DOCUMENT 00 91 13

Addendum Number Two

PROJECT: ITD D5 Maintenance Building Addition and
Renovation and New Brine Facility
Blackfoot, Idaho

PROJECT NO.: 22569

SHEET **P100**

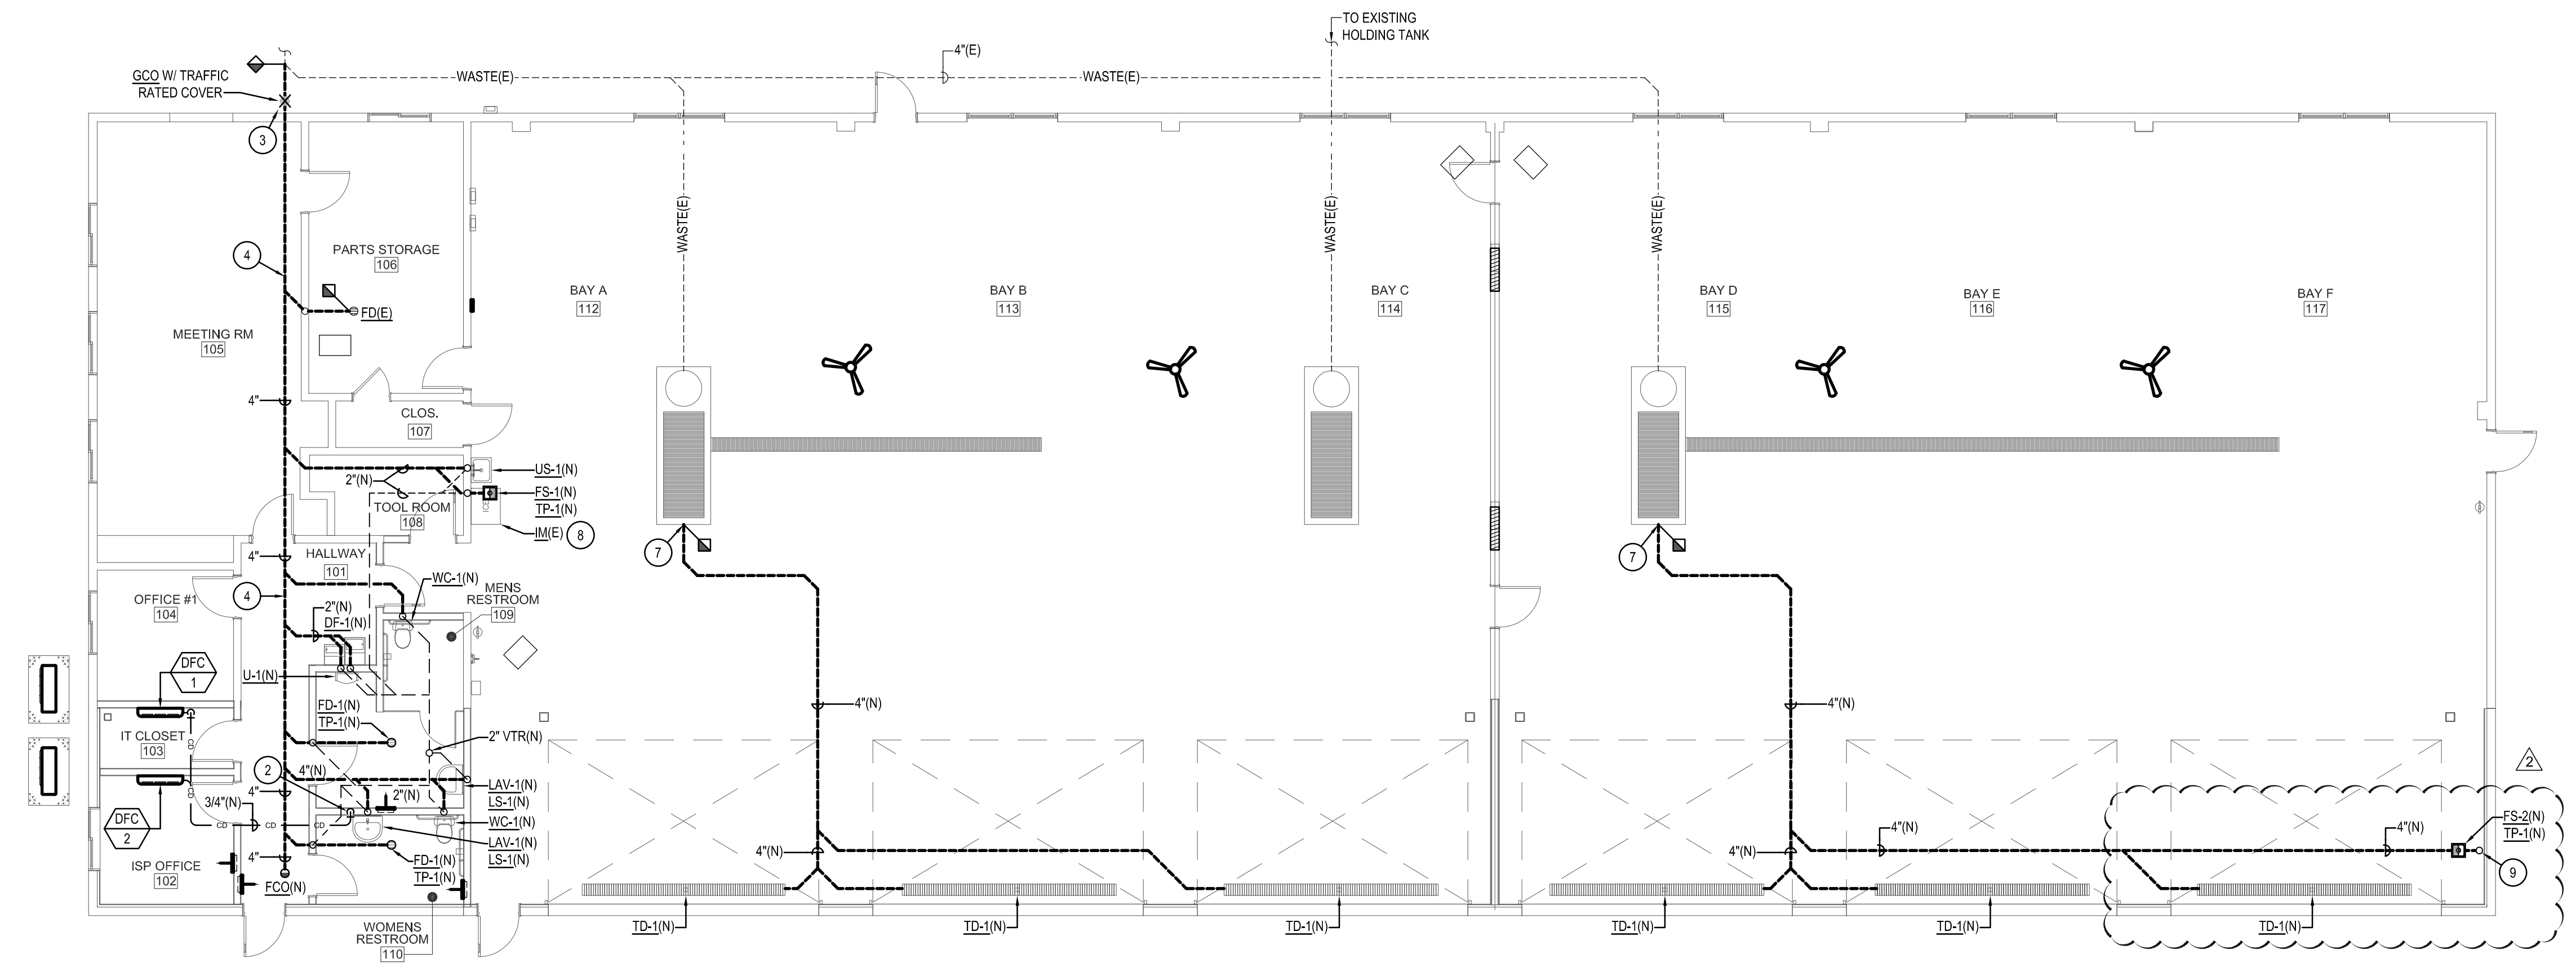
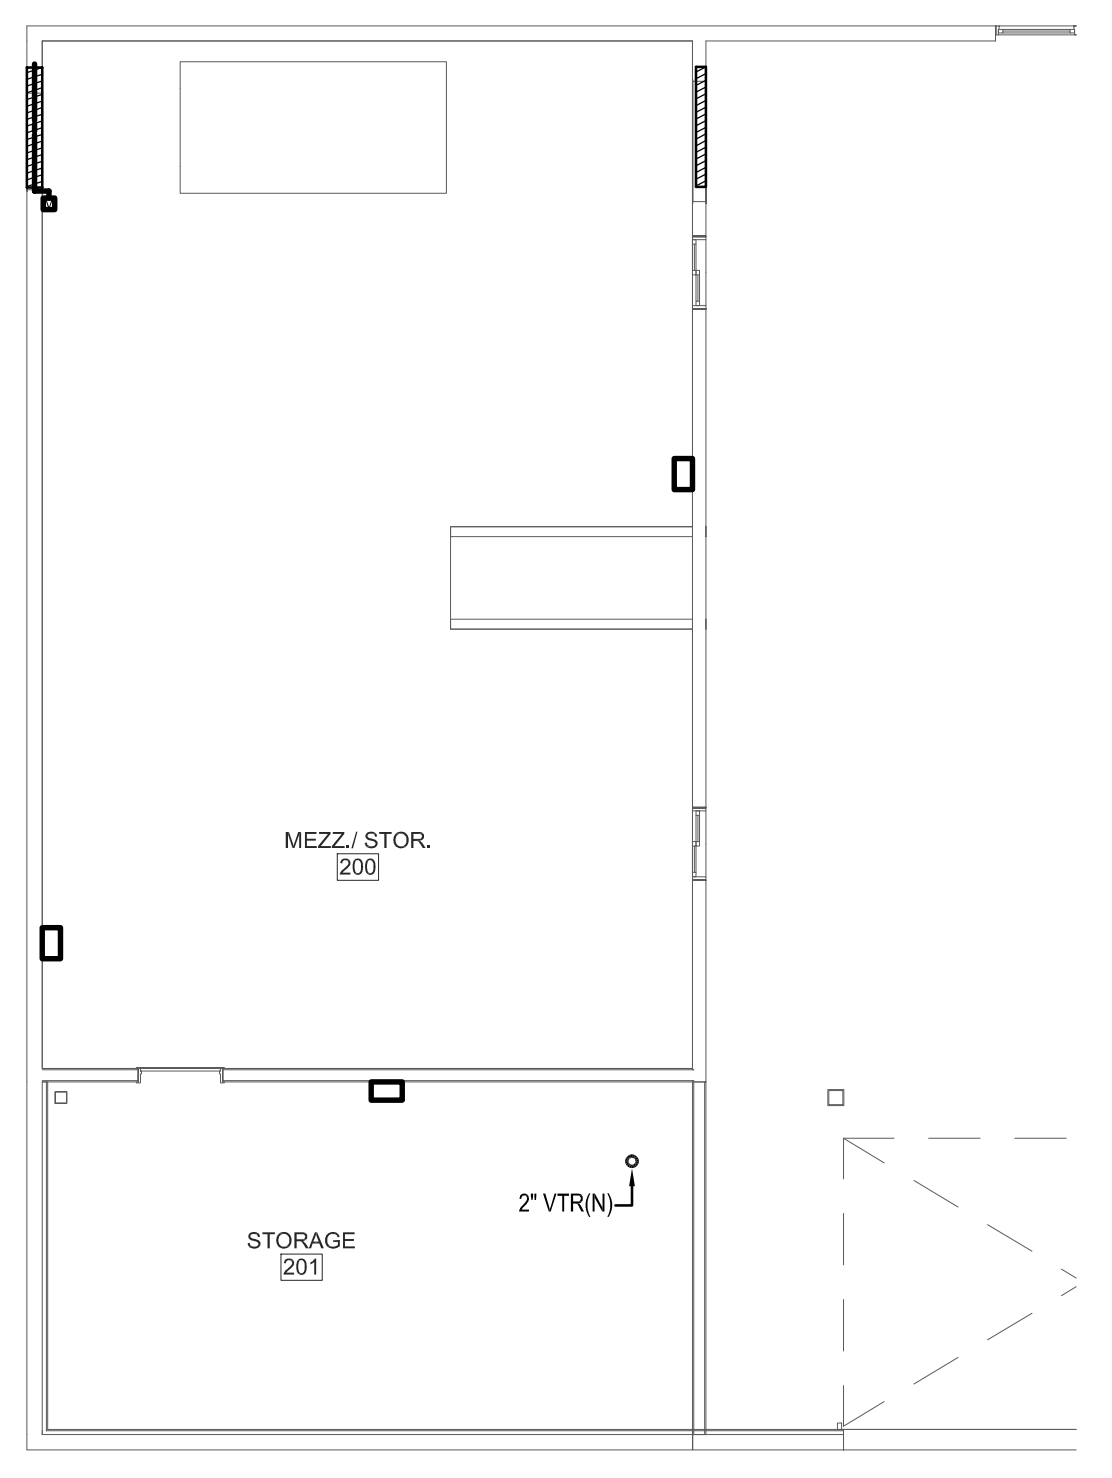
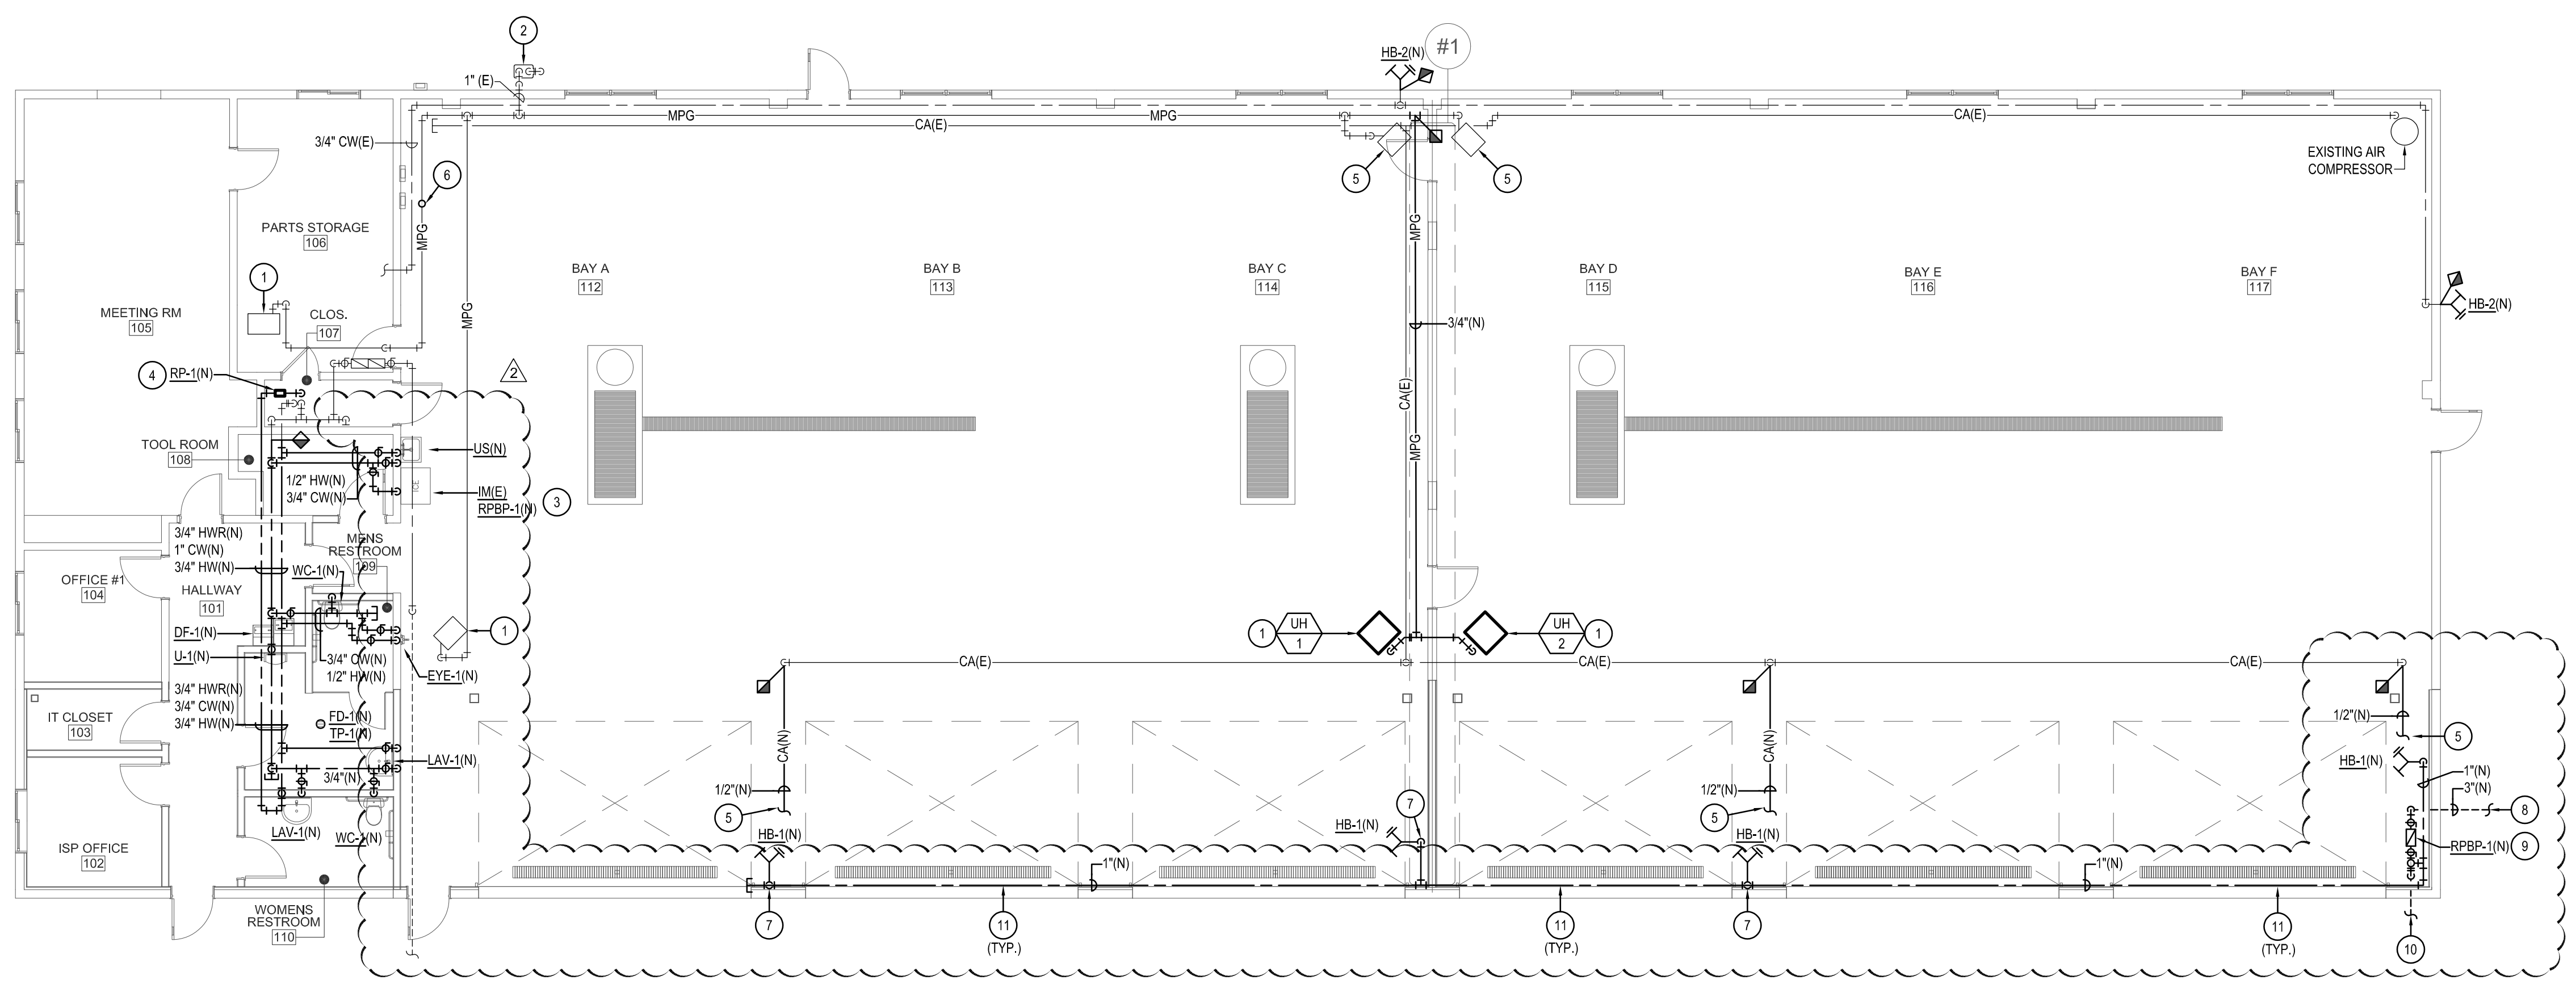
2. Replace Sheet P100 – Plumbing New Work Plan – Waste And Vent with attached Sheet P100 – Plumbing New Work Plan – Waste And Vent. Revisions are as follows.

- a. Added floor sink & trap primer in Bay F (FS-2 & TP-1).
 - b. Added 4” waste and 2” vent connections.
 - c. Updated Keynote #6: “NOT USED”.
 - d. Added Keynote #9.

- e. Updated sheet title.
3. Replace Sheet P101 – Plumbing New Work Plan with attached Sheet P101 – Plumbing New Work Plan – Water and Gas. Revisions are as follows.

1 PT01 PLUMBING NEW WORK FLOOR PLAN – WATER AND GAS
 SCALE: 1/8" = 1'-0"

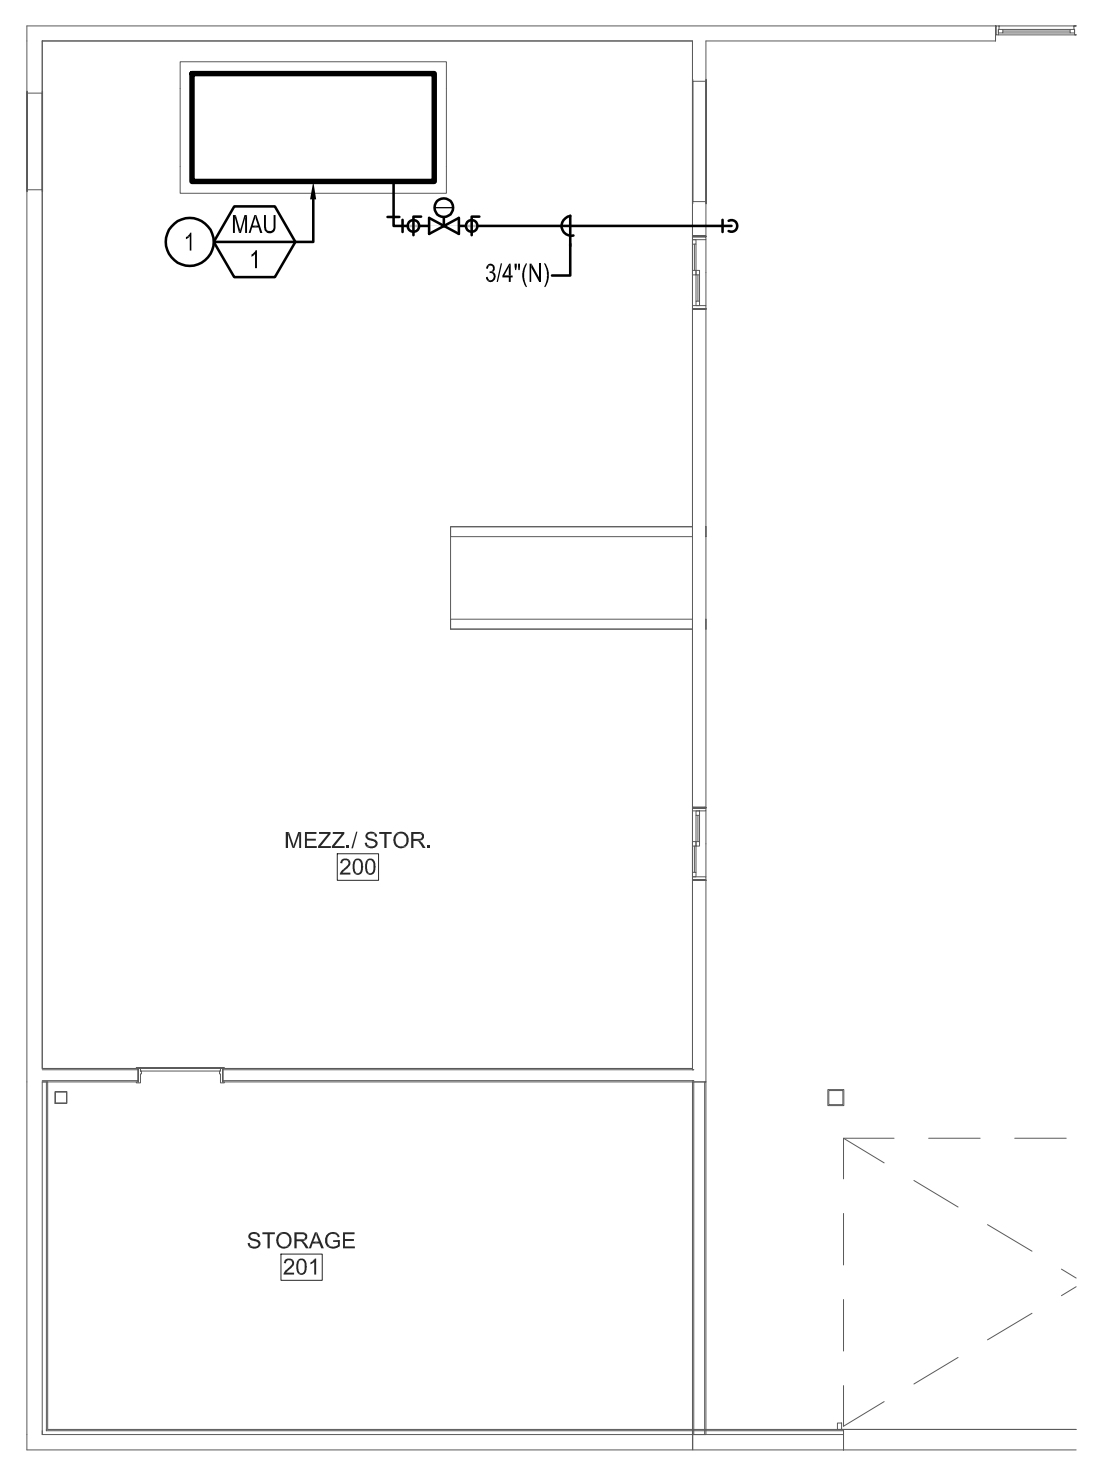
- a. Added new 3” non-potable cold-water line and reduced pressure backflow preventer (RPBP-1) to Bay F.
 - b. Revised routing of 1” non-potable cold-water line from this new 3” non-potable water connection after the backflow device.

- c. Added Keynotes 8, 9, 10, & 11.
 - d. Removed
 - e. Updated sheet title.
4. Replace Sheet P102 – Brine Plumbing New Work Plan with attached Sheet P102 – Brine Plumbing New Work Plan. Revisions are as follows.
